**PLANNING COMMISSION
STAFF REPORT**

August 06, 2020

AGENDA ITEM: Planning File No. 011-20-MAJ: A review of the Major Site Plan Application for a proposed new multi-family townhome project

LOCATION: 317 Granite Street / Lots 21-24, Block 9, Frisco Townsite

August 2020 Full Site Plan

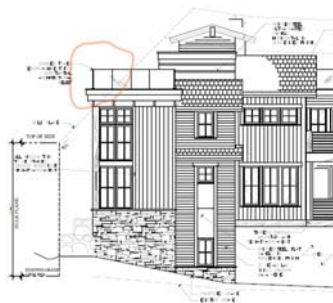
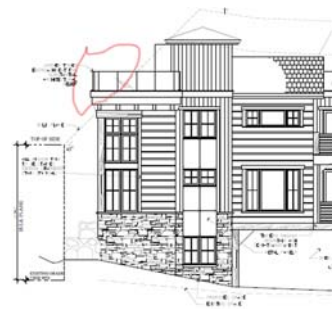
During the May 7, 2020 sketch plan review, Planning Commissioners expressed concern over the bulk plane encroachments and stated they would prefer they not exist. In response to Commissioners concerns, the application has reduced the proposed bulk plane encroachments. The proposed bulk plane encroachment on Unit 5 is 30 cubic feet and the proposed bulk plane encroachment on Unit 9 is 72 cubic feet. See below comparisons of bulk plane encroachments illustrating encroachments proposed at sketch plan versus current proposed bulk plane encroachments.

Bulk Plane Encroachment, East Elevation

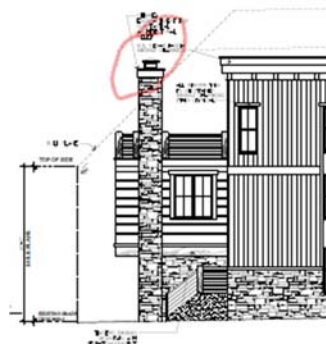
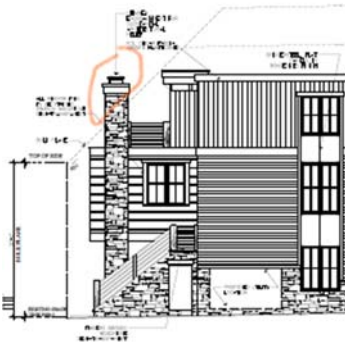
Should the Planning Commission find that the encroachments provide substantial architectural relief and advance the intent of Section 180-6.23, then the application meets this standard.
